NHTSA Recall 18V-642

SAFETY RECALL NOTICE

Service Bulletin

Bulletin Number: **SB-18-297 Revision B**
 Release Date: **September 28, 2018**
 Subject: **Inspection of Hydraulic Oil Tank Mounting Brackets**
 Distribution: **Affected Customers/End Users/Key Accounts, Customer Service, Field Service**

Figure 1. Hydraulic Oil Tank Mounting Bracket Locations (Each Side of the Hydraulic Oil Tank)

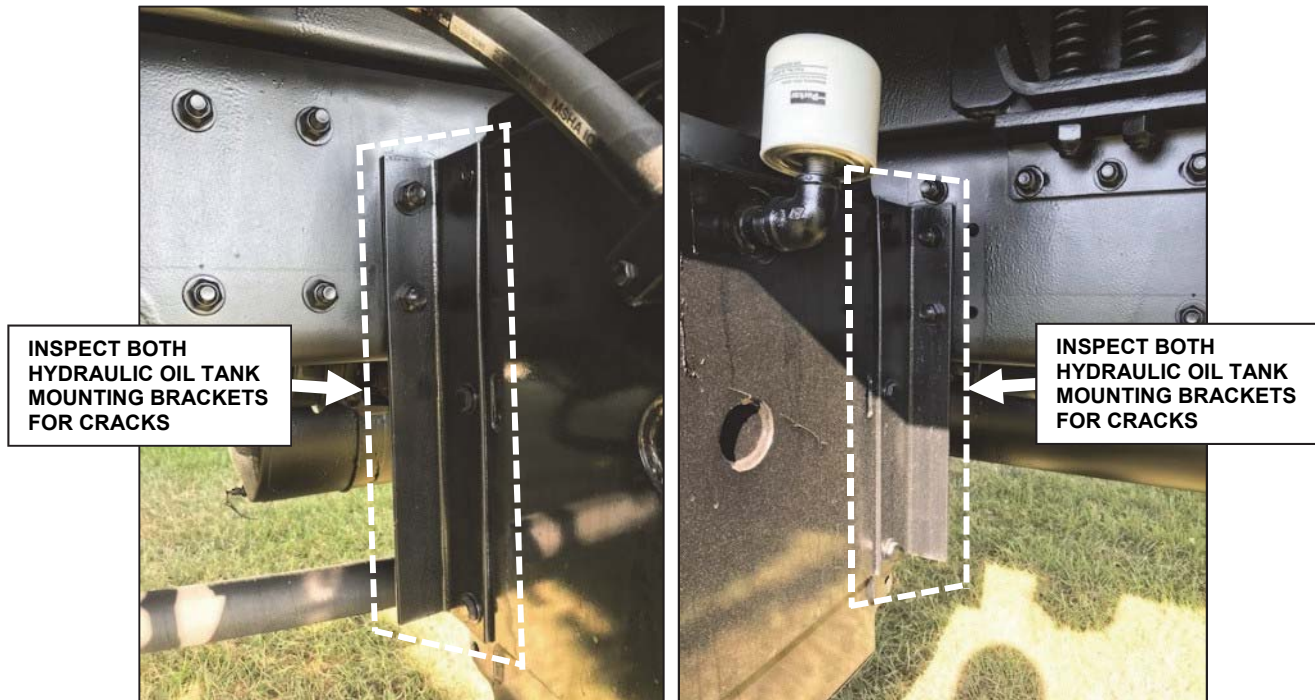
- (1) Inspect both hydraulic oil tank brackets for cracks. Note: The brackets will require periodic cleaning to ensure the inspector's visibility of any cracking is clear.
- (2) If any cracks are found, contact your local Heil Dealer immediately to have the brackets replaced.
- (3) If no cracks are found, no corrective action is required at this time, however, routine inspections as set forth herein should continue.
- (4) **Hydraulic Oil Tank Mounting Bracket inspections should be added to the operator's pre- and post- trip inspection procedures.** Additionally, bracket inspections should be added to regular Preventive Maintenance schedule to be inspected daily (every 8 hours of operation). **Replace BOTH brackets immediately if ANY cracks are found.**
